Scapa Deep Water Quay Supplementary Environmental Information Report

May 2025

Client: Orkney Islands Council Harbour Authority
Project Title: Scapa Deep Water Quay
Report Title: Supplementary Environmental Information Report
Document number: 15243
Project number: 679084

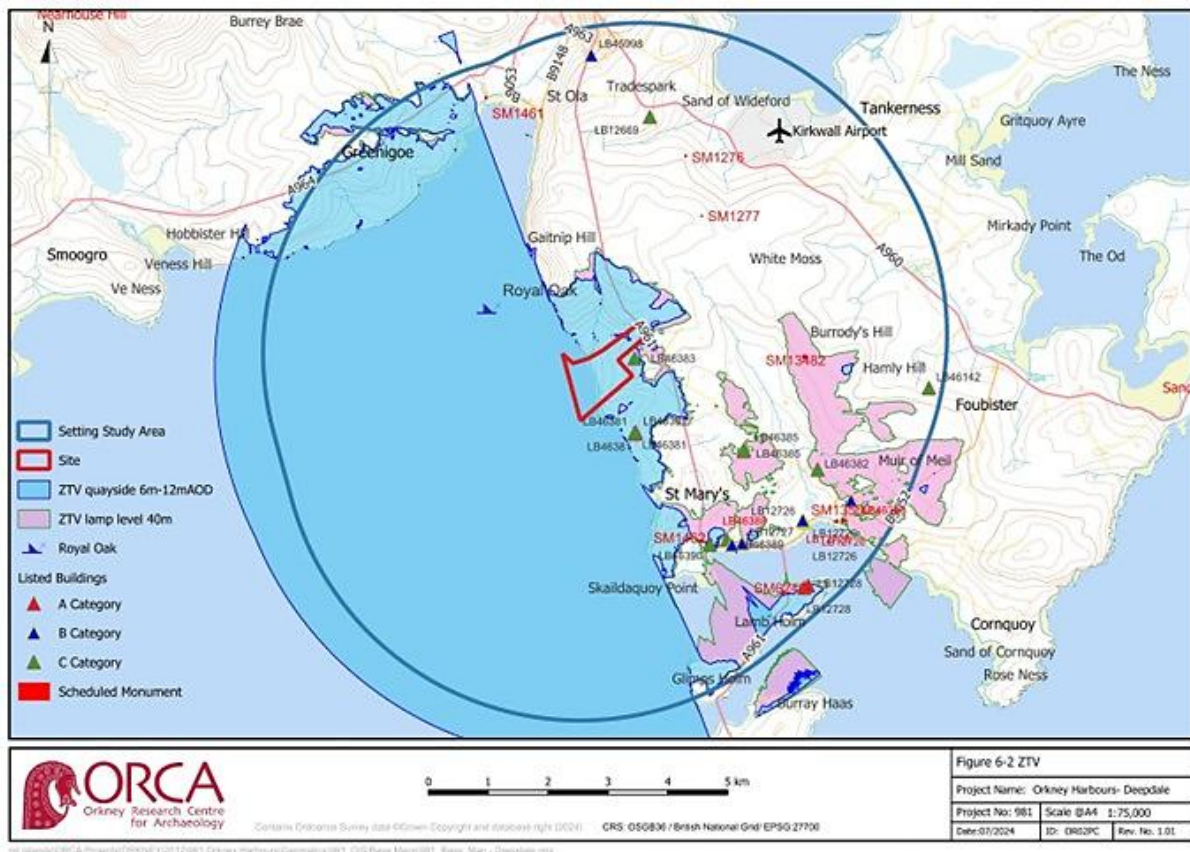
Consultation feedback stated ‘EIAR Figure 6-2 ZTV is a crude image that lacks detail and does not appear to correlate with SLVIA ZTV Figures 7-5 and Figure 7-7 in Volume 2 of the EIAR. No study area has been shown on the figure.’

An updated Figure 6-2 has been added below.
